A1 in Northumberland: Morpeth to Ellingham

7.6D Statement of Common Ground with Historic England

**Statement of Common Ground with
Historic England**

Rule Reference:	8(1)(c)
Planning Inspectorate Scheme Reference	TR010059
Document Reference	7.6D
Author:	A1 in Northumberland: Morpeth to Ellingham Project Team, Highways England

Prehistoric burial mound 420m north-west of East Linkhall

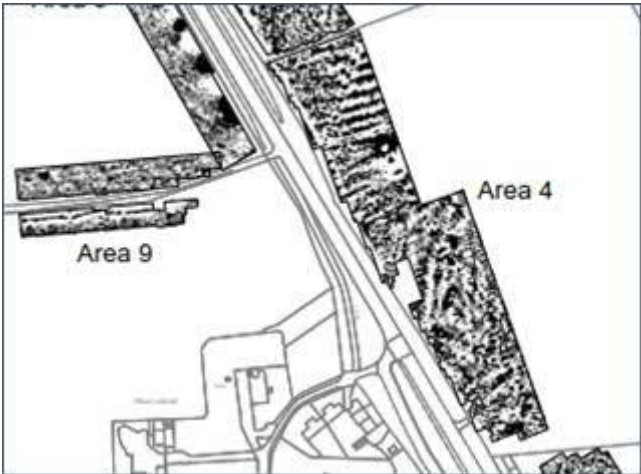
The information provided at this stage rightly highlights the proximity of this scheduled site to the proposed development. We broadly welcome the default position set out in the consultation, which is to avoid the scheduled area with any development activity.

However, we note that at this stage whether this avoidance is achievable, or whether the development will require an impact (up to the total destruction of the bowl barrow), is unclear. Clearly which of these scenarios applies makes a huge difference to the potential impact of the development on the historic environment, and how it needs to be treated in NPPF terms: total avoidance could mean the development avoids any impact, whereas development requiring removal of the monument would be regarded as substantial harm to this nationally-significant heritage asset, something that would require Highways England to provide clear and convincing justification (NPPF Paragraph 194) and to demonstrate that this harm is *necessary* in order to achieve substantial public benefits which outweigh this harm (NPPF Paragraph 195).

The scheme design has now been updated to remove the proposed detention basin from this location and to exclude the entire field containing this Scheduled Monument from the application boundary. The assessment will now be addressing potential impacts on this asset due to change in setting only.

North Charlton Scheduled Monument

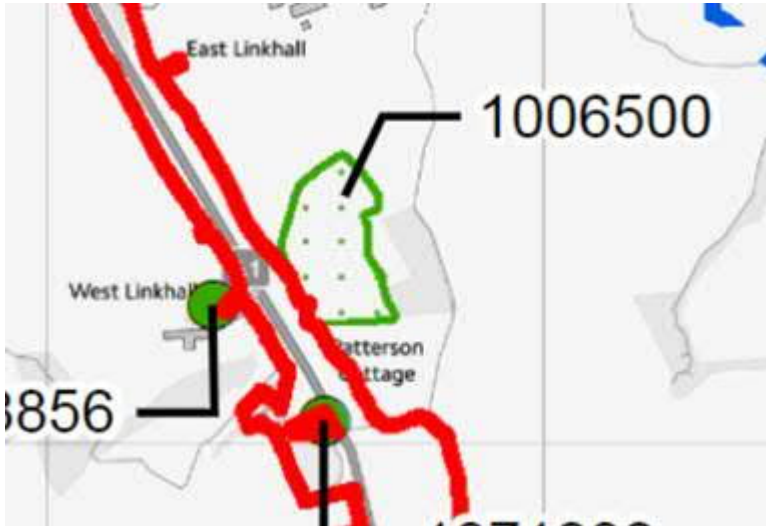
1.2	MC queried the extent and boundary of the Scheduled Monument as shown on the plan and plotted on the ground on site. AG explained that it had been marked out on site by PCA using GPS system. The trenches and test pits were located several metres from the boundary to take account for any inaccuracies in the GIS data and the GPS stakeout.	AG to provide images from site showing trench location	ASAP

1.3	MC queried the location of the earthworks thought to represent the surviving tail end of ridge and furrow, a key element of the Scheduled Monument, in relation to the scheme boundary. AG explained that these landscape features lay within the designated area when it was set out, haven't been evaluated and will not be impacted by the Scheme.	AG to provide images from site showing trench location	ASAP

The first relates to the boundary of the North Charlton Scheduled Monument, the earthworks (the “combs” in particular), and the location of the works. I understand the concern, especially seen as though the western end of the scheduled monument boundary isn’t marked by an existing field boundary. However, when PCA did the evaluation works, the first activity they did was to mark out the exact boundary of the scheduled monument using a GPS. This revealed that the east-west aligned earthworks on the top of the long north-south linear bank are located within the Scheduled Monument boundary. I had a look through my photographs taken on site during the works – attached is the best one I could find to illustrate it (Attached Image: North Charlton, facing south). This photograph is taken at the end of the southern most trial trench, looking towards the southern end of the Scheduled Monument. The red and white tape line on the left hand side of the photograph is the line of the monument. You can see the “combs” lie on the other side of the tape line. The ground rises upwards at the southern end of the site, and it is my belief that some, if not all, of this material originally lay across the area we evaluated but has been moved.

West Linkhall Scheduled Monument

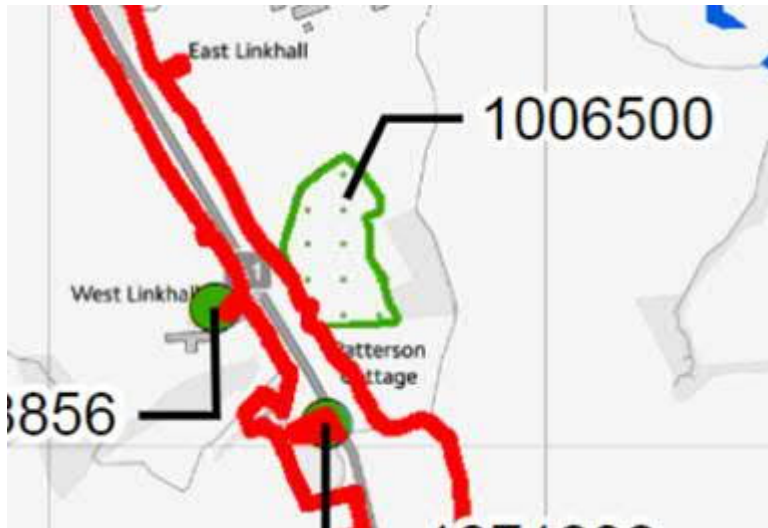
5.1	AG and MC discussed the conclusions of the assessment of impact on the setting of the Scheduled Monument. MC agreed broadly with AG's assessment that the impacts would not constitute substantial harm, however the information provided in October did not show the proposed dualled scheme or the proposed landscape mitigation. This needs to be reviewed before assessment confirmed.	AG to supply relevant extract from the landscape plan	ASAP
6	Statement of Common Grounds

The second query was the impact on the setting of the scheduled monument Camp at West Linkhall . Below is the scheme design in this location. The existing road will be widened to the east, towards the monument. There will be haul running along the east side of it. The current highway here is elevated and runs on an embankment, and the scheme design includes widening the embankment. The embankment will then drop towards the scheduled monument, but will fall short of its boundary. I have attached a photograph taken on the site (Image: Camp at Linkhall). This is taken from the north end of the site looking south. Please let me know if you need any more information.
